Service Bulletin

Engine Harness Rubbing – BC3-6560 only

Inspect in this area on the back side of the harness

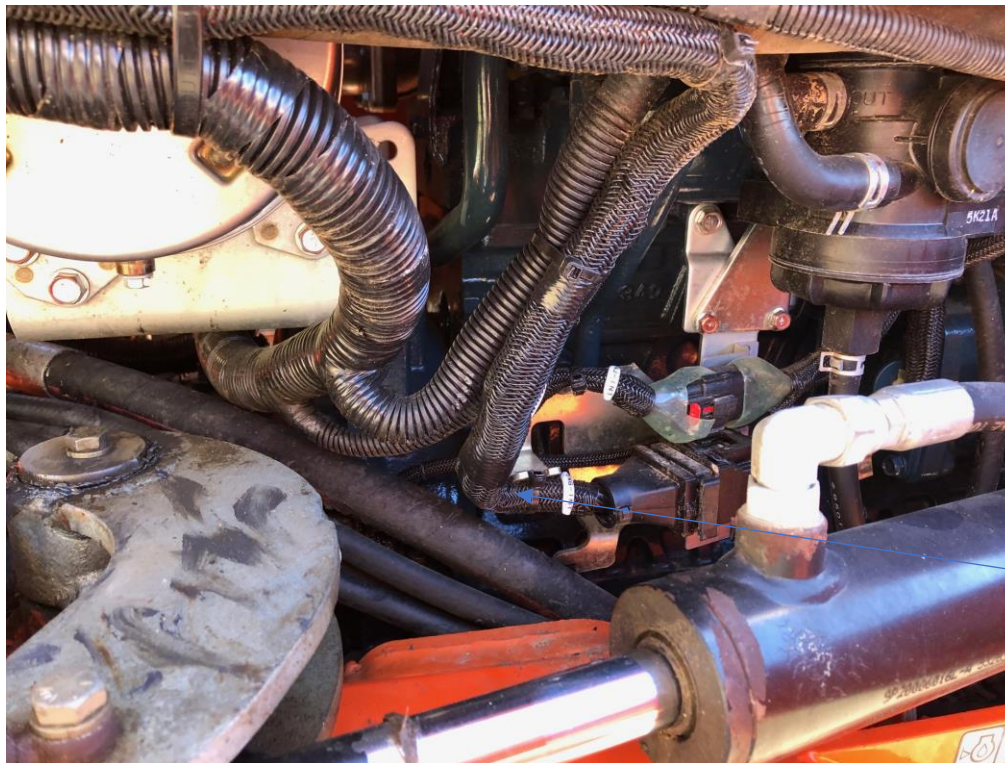
Please be aware that there may be an issue with the Kubota intermediate engine harness rubbing on the bracket mounted to the engine. Bright Coop has been notified of several issues in the field, and upon investigation, we have found that the hydraulic hoses may shift and cause this rubbing issue.

We are advising our customers, with a serial number less than 89, to inspect and correct this issue by either moving the harness to the top of the bracket, bending the bracket on the engine to ease the pressure from the hydraulic hoses, or both. The inspection area is on the back side of the engine, just to the right of the swing arm for the steer axle.
